Request for NRC to Critique the Article on
"Reducing the Hazards from Stored Spent Power -
Reactor Fuel in the U.S."

SUBJECT: Concerns comments received from NRC regarding the article by Alvarez, et al., published in the Science and Global Security

I am one of the reviewers of the paper entitled: "Reducing the Hazards from Stored Spent Power-Reactor Fuel in the United States," and am also the principal author of the Sandia report that is cited several times by the authors of the paper. The subject of spent-fuel pool vulnerabilities is a very important one in the present day environment, and I am pleased to be able to provide input. I think the paper correctly points out a problem that needs to be addressed, i.e., the fact that a loss of water from a high-density spent-fuel pool could have serious consequences. However, I also believe the paper falls short of addressing all the considerations that accompany the problem. Some of these considerations could affect the results of the cost-benefit analysis that is used to justify the authors' proposed solution: the re-racking of the pool to a low-density, open-lattice arrangement and the removal of the older fuel to dry storage casks.

Figure 8: Neutron multiplication as a function of array pitch in an infinite square array of 4.4% enriched fuel rods with a design burnup of 53 MWd/kgU for 0, 25, 50, 75 and 100% irradiation (Source: authors).

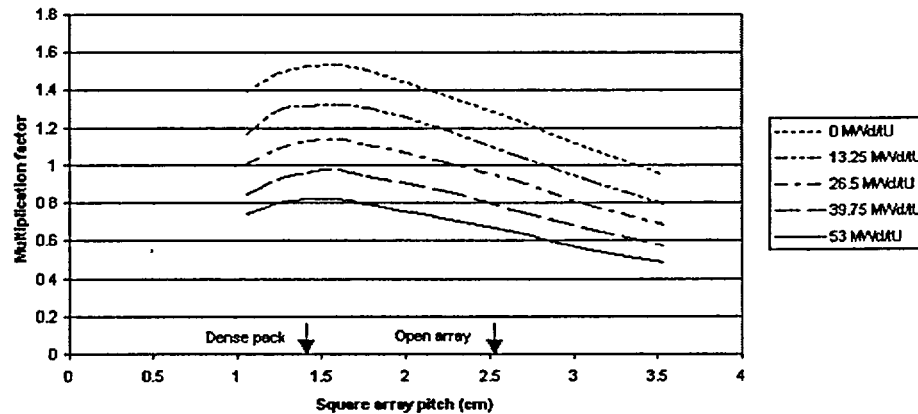
6. Page 20 discusses the potential for criticality accidents in open-rack storage if the fuel racks are crushed. Figure 10 is difficult to interpret because it has several unlabeled curves. But it is hard to envision a crushing event that would uniformly rearrange spent fuel in such a way that k-infinity calculations (which assume an infinite, uniform fuel lattice) are relevant to predicting the potential for criticality.
